Response to Reviewer 1

The study combines multiple existing wastewater treatment plant (WWTP) datasets, supplementing available information with additional (inferred) plant characteristics, to produce a consistent and coherent global dataset of wastewater treatment plants. Information captured within the dataset includes both geographical location and important plant characteristics such as flow rates and treatment level. The authors calculate an average wastewater treatment plant dilution factor, and link WWTP outfall locations to the river network, to calculate the length of the stream network downstream of WWTPs as a basic indicator for identifying areas of potential environmental concern. Overall, I believe this work to be both of high quality and interest for the scientific community. The manuscript clearly describes the dataset and is mostly well written, although I would recommend some edits to improve readability (particularly shortening sentences!). Therefore, after some revisions, I would recommend publication in ESSD. Please see my detailed comments below for my recommendations on how the manuscript could be further improved.

Thank you for this comment. We agree with y

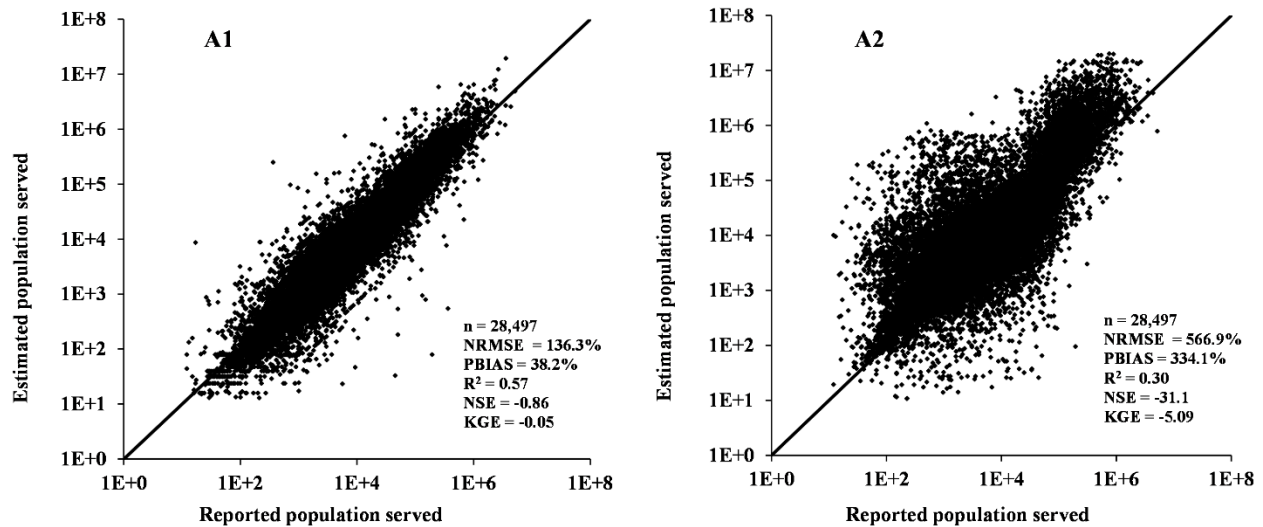
For estimating the missing attributes for “population served”; I suggest the authors conduct and reflect upon the sensitivity of their results to their assumptions. The authors select the minimum value calculated from the three methods, but how do the results look if one method is used consistently instead? Also important to reflect upon the uncertainty of these derived attributes in general.

The combination is used to reduce uncertainties of the individual methods, and we do agree that showing the sensitivity of results for each method could reinforce our decision to combine them. We therefore conducted an additional sensitivity analysis and added a section in the Supplement to present and discuss this analysis. To inform the reader about this addition, we added a reference in parenthesis in the main manuscript at line 285:

When applied to all existing validation data, approach A1 on its own (Fig. S2, left panel) shows a similar scatter plot and comparable goodness-of-fit parameters as the final method (Fig. 4a in main manuscript). This is because A1 provided the minimum (i.e., final) value more frequently than the other approaches in this evaluation (70%). Approach A2 (Fig. S2, right panel) resulted in more bias towards overestimation, especially for smaller WWTPs. However, even if approach A1 was generally superior to A2, approach A1 requires that a reported treated wastewater discharge value exists, which is not the case for 6,542 records of HydroWASTE.

Figure S6. Frequency distribution of calculated dilution factors (DFs) at low flow conditions of all the WWTPs in the HydroWASTE database (for exceptions, see main manuscript, section 3.2).

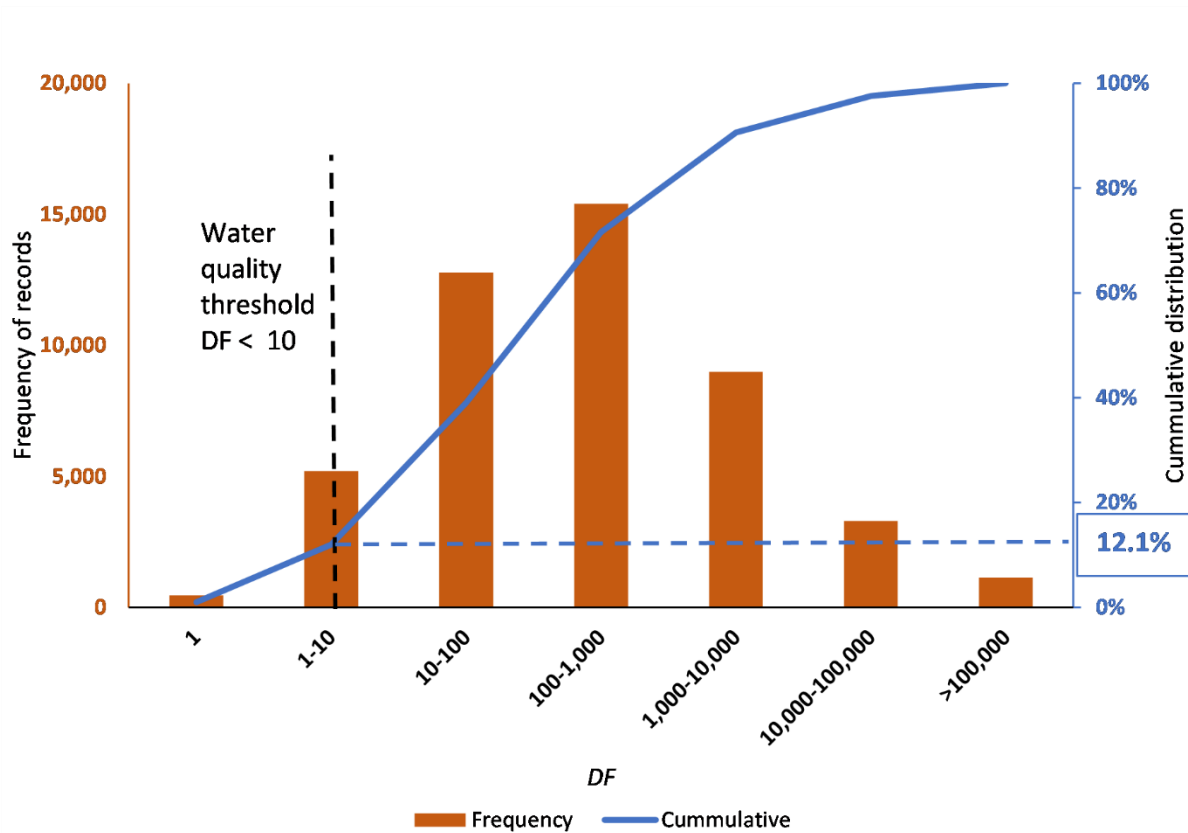
It would be very interesting to see how the dilution ratio varies intra-annually, due to large seasonality in river discharge. However I do appreciate that the analysis presented in this paper is more with the

purpose of showcasing the HydroWASTE dataset. If possible, analysis of the seasonality in dilution ratios would further improve the manuscript, but is not essential.

We agree with the reviewer that it would be very interesting to see the seasonality in dilution factors. However, it is not only the river discharge that varies intra-annually, but also the treated wastewater discharge, for which we do not have any temporal information. Still, following the reviewer suggestion, we decided to include an analysis of dilution factors and treated wastewater ratios under low flow conditions, using the same average treated wastewater discharges but instead of the long-term (1971-2000) average river discharge we used the minimum monthly discharge in an average year.

Figure 5 now has a version for low flow conditions included in the Supplement.
